Planning & Inspections Department
153 Courthouse Road, Suite 110
Currituck, North Carolina 27929
252-232-3055
FAX 252-232-3026
RE: New Bridge Creek Subdivision

In response to the Technical Review Committee Comments dated June 22, 2026, the following items are enclosed with this submittal:

Currituck County Planning & Inspections Department
New Bridge Creek Subdivision
BPG Project 4778
August 3, 2026

DEMOLITION, EROSION & SEDIMENT CONTROL PLAN (PHASE 1)

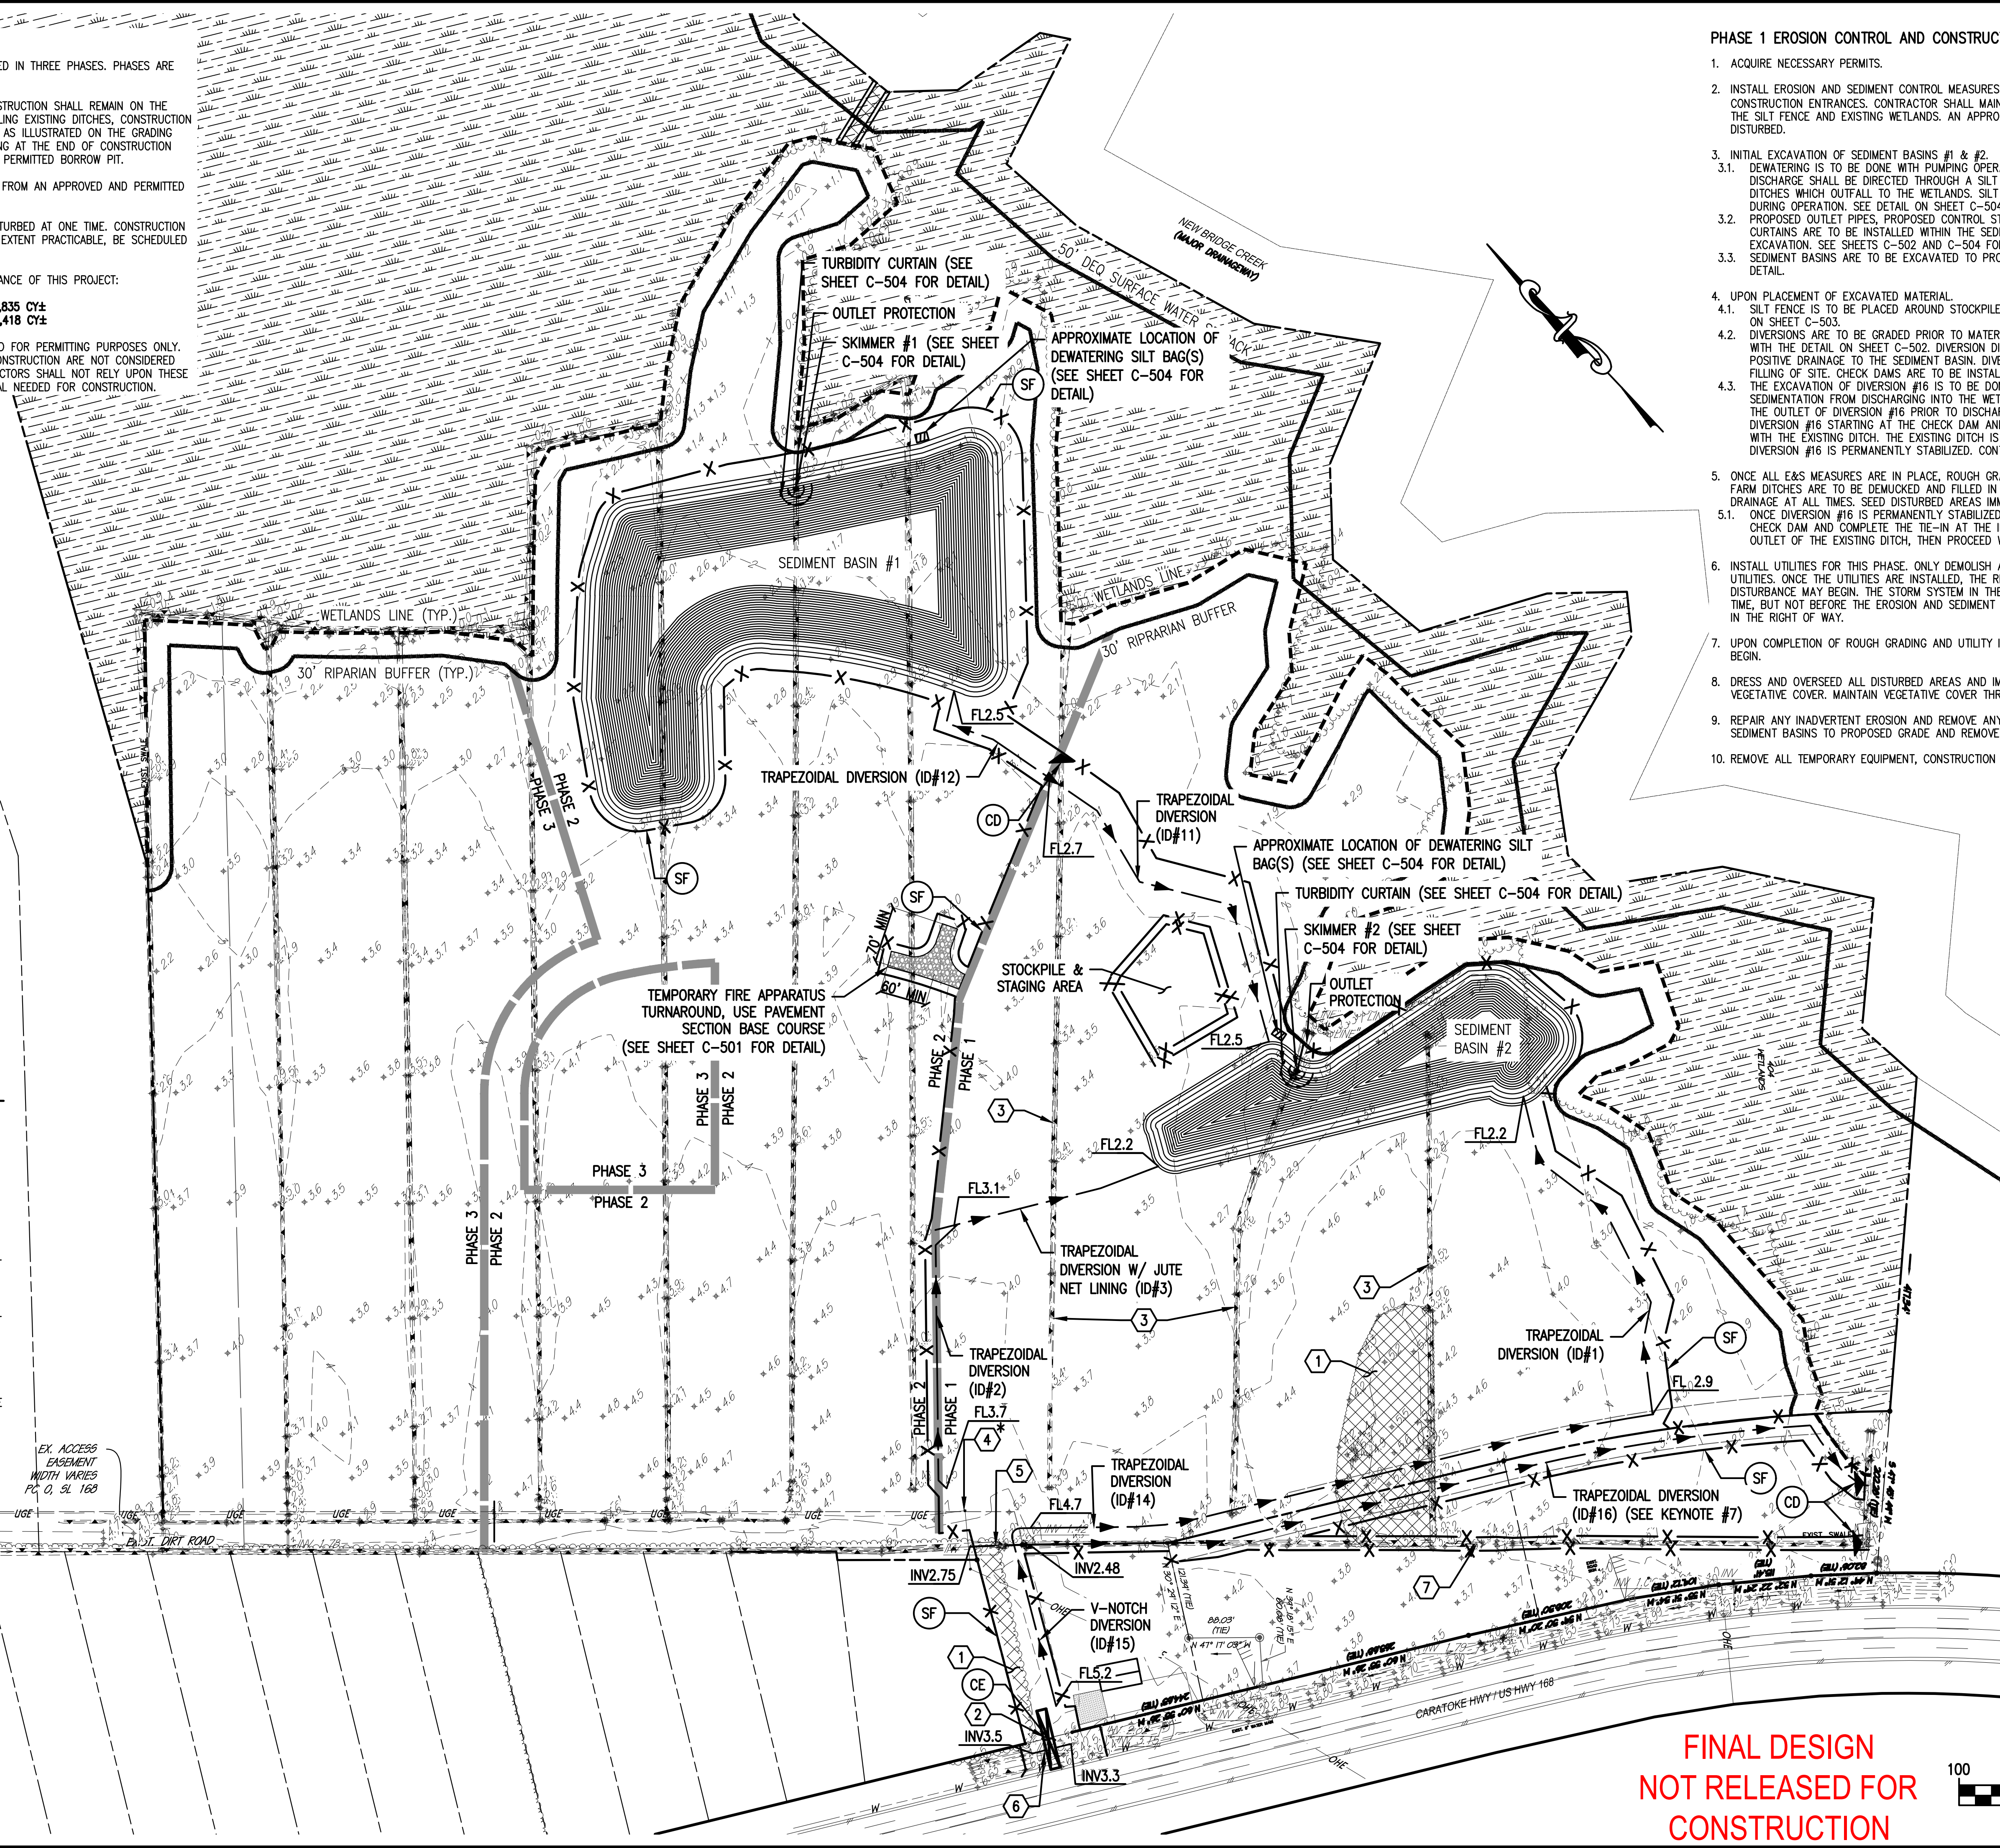
1. The installation of the vegetative buffer between the subdivision and the northern property will be completed at Phase 1.
2. Applicant's submitted phasing schedule below shall be adhered to:

Response: On CL101 the northern buffer plantings are now noted to be completed in phase 1. On the cover sheet (C-001) a phasing summary consisting of the # of lots & earliest recordation has been added to the development notes, in accordance with the approved phasing schedule.

SHEET
CG102
 8 of 32 Sheets
 SCALE: 1" = 40'
 PROJ. NO.: 24102

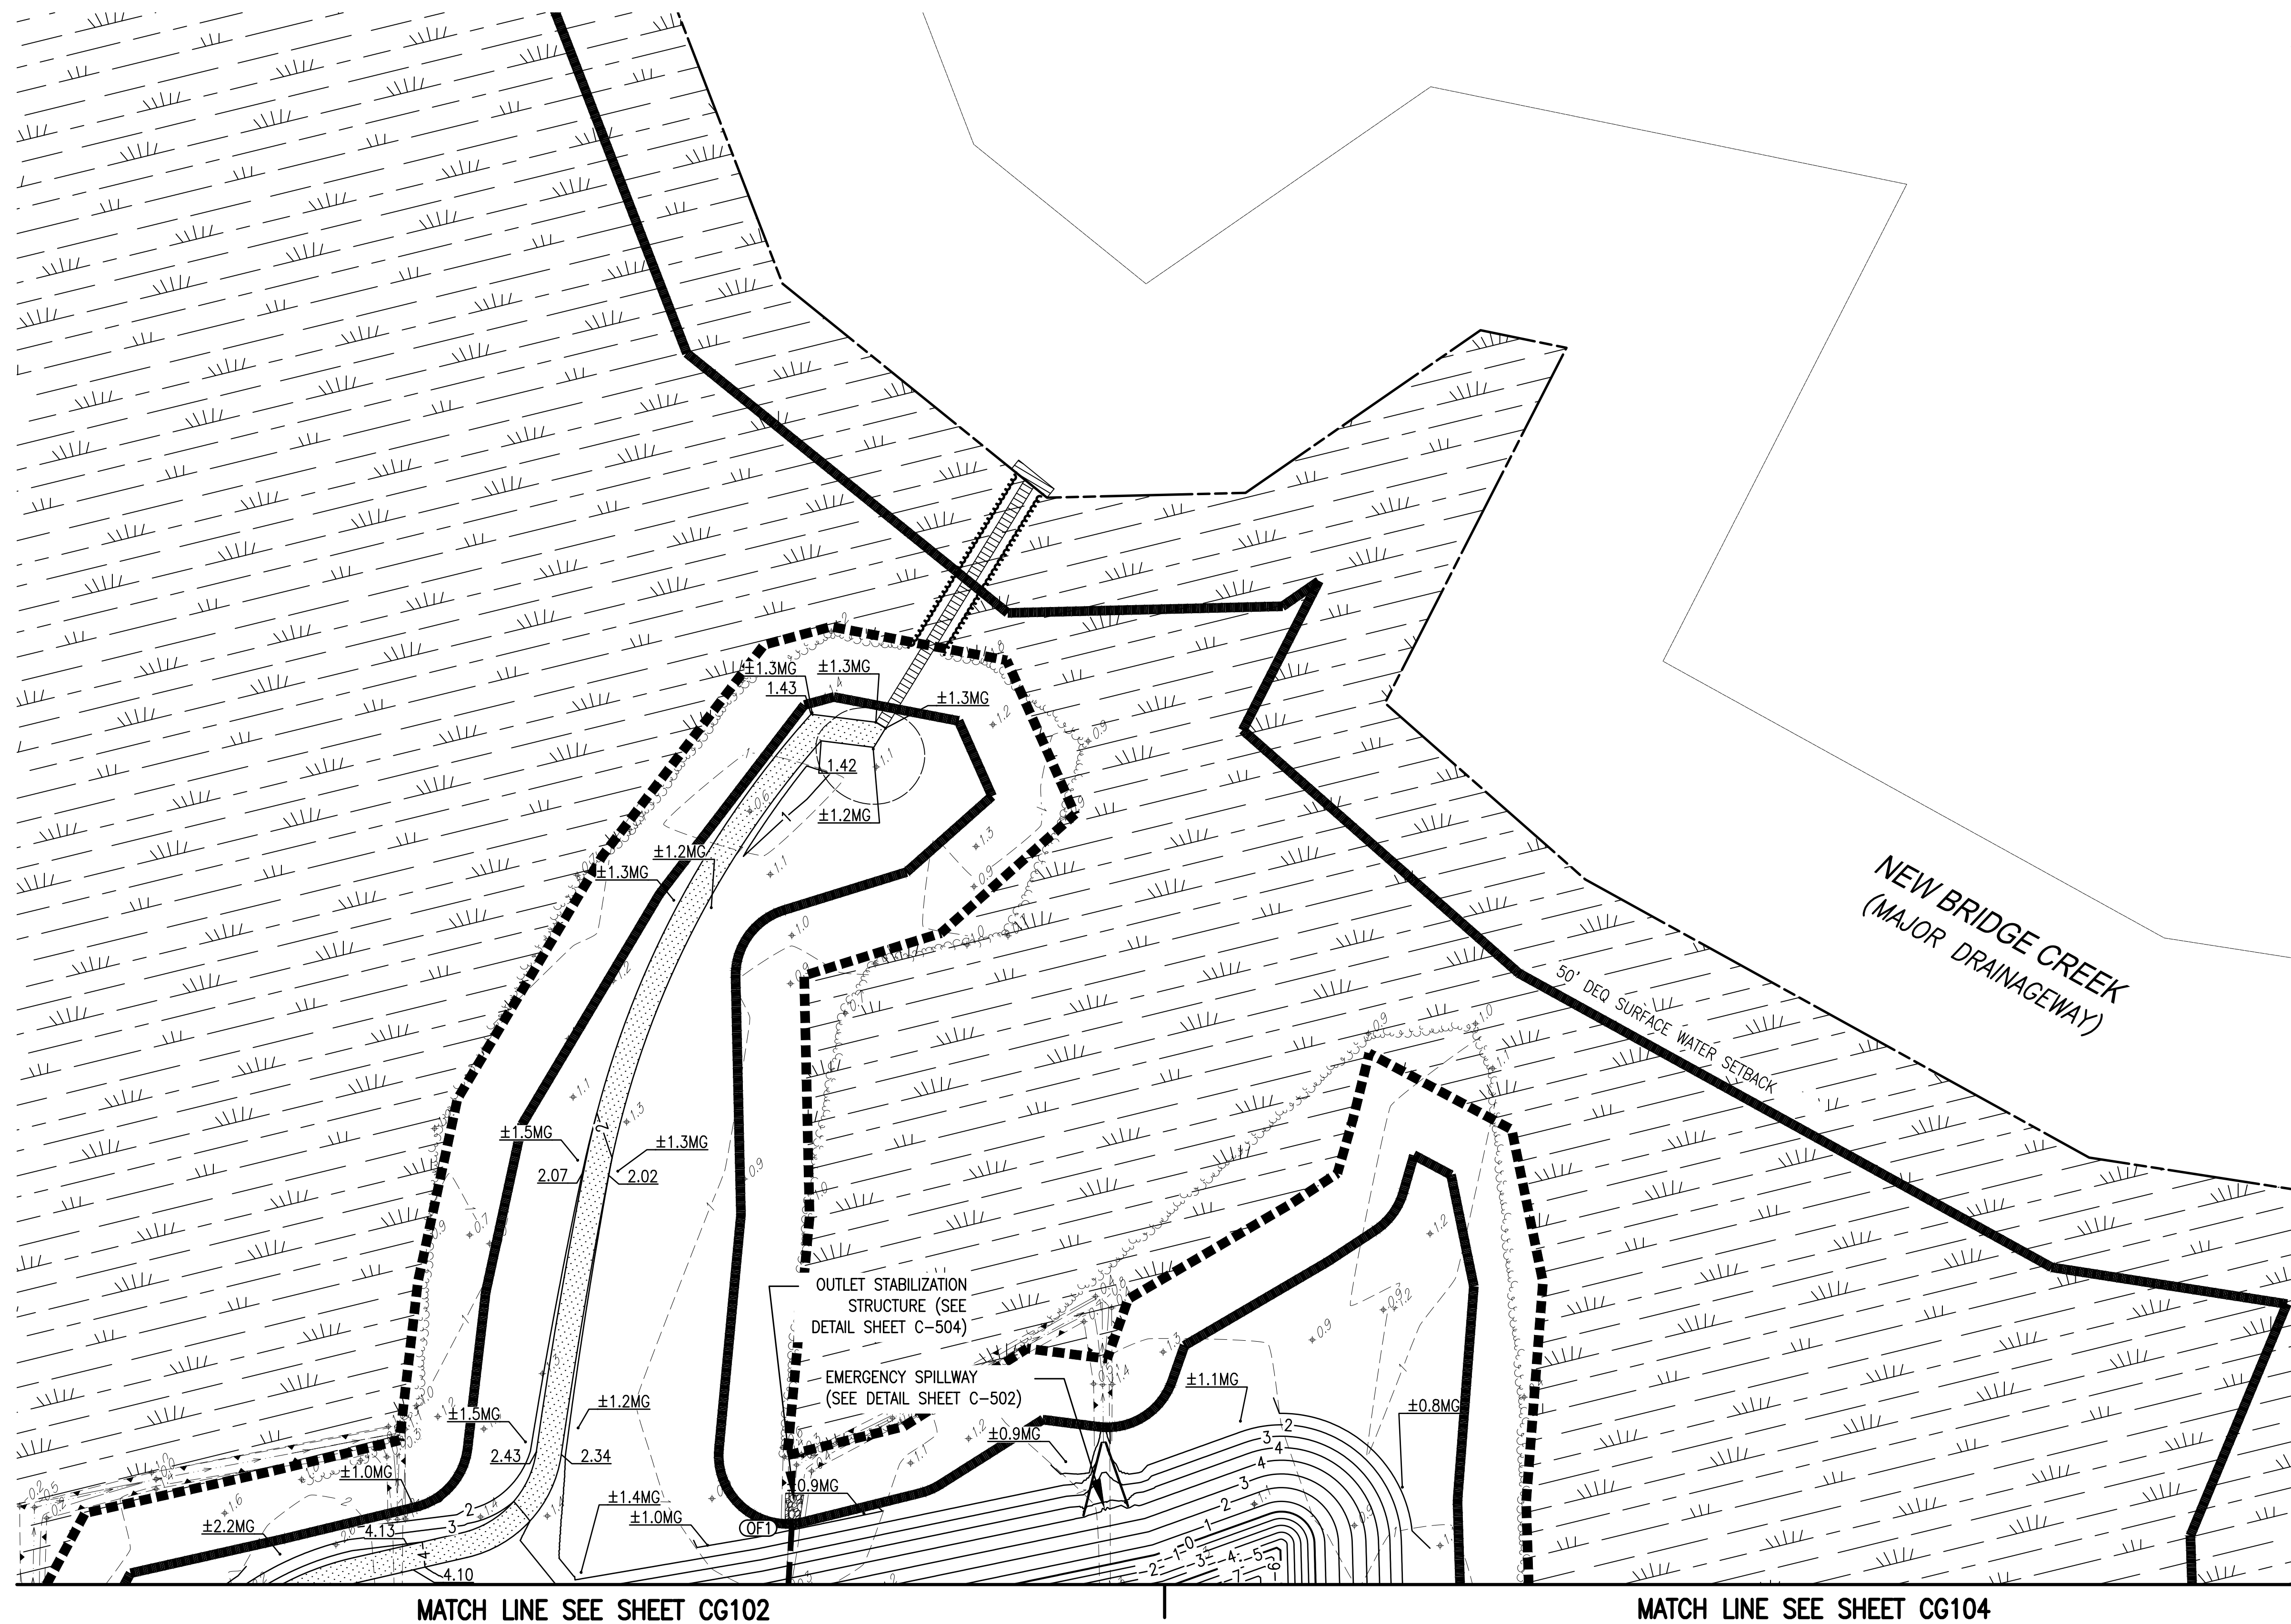
3. Please add the finished floor elevations to the plans.
Response: Noted on sheets CG101-105 the minimum finished floor elevations are equal to the building pad elevations shown.

MINIMUM FINISHED FLOOR ELEVATIONS
ARE EQUAL TO BUILDING PAD
ELEVATIONS (BPE) SHOWN HEREON

SHEET
CL101
17 of 32 Sheets
SCALE: 1" = 100'
PROJ. NO.: 24102

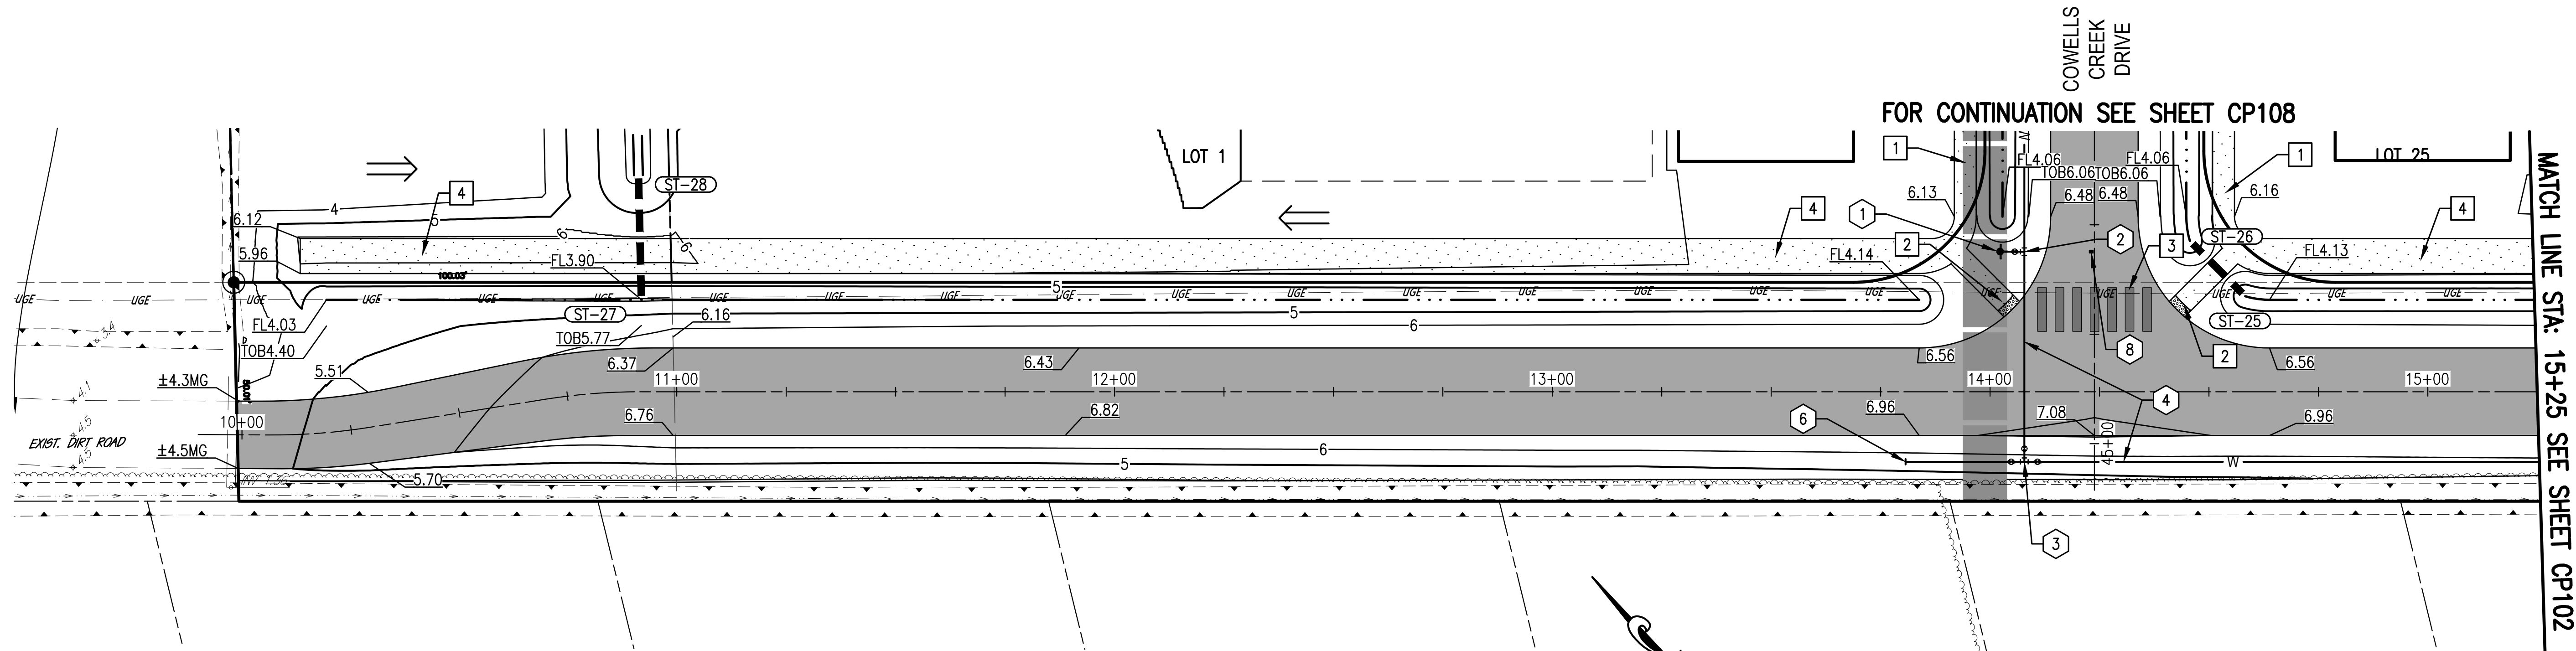
4. Show the locations of all signage: development entrance, no parking, street signs, stop signs.
Response: Updated signage is shown on sheet CL101.
5. Please add site triangles.

Response: Site triangles are shown on sheet CL101
6. Were there previous discussions regarding Recreation and Park Area Dedication?
Response: Yes; a 0.9-acre parcel was offered to Currituck County at the preliminary plat stage and was not accepted, so a fee-in-lieu will be paid at the final plat stage.

7. The development shall adhere to the Special Use Permit conditions of approval below:

PROPOSED BUFFER
PLANTINGS TO BE-
COMPLETED IN PHASE 1
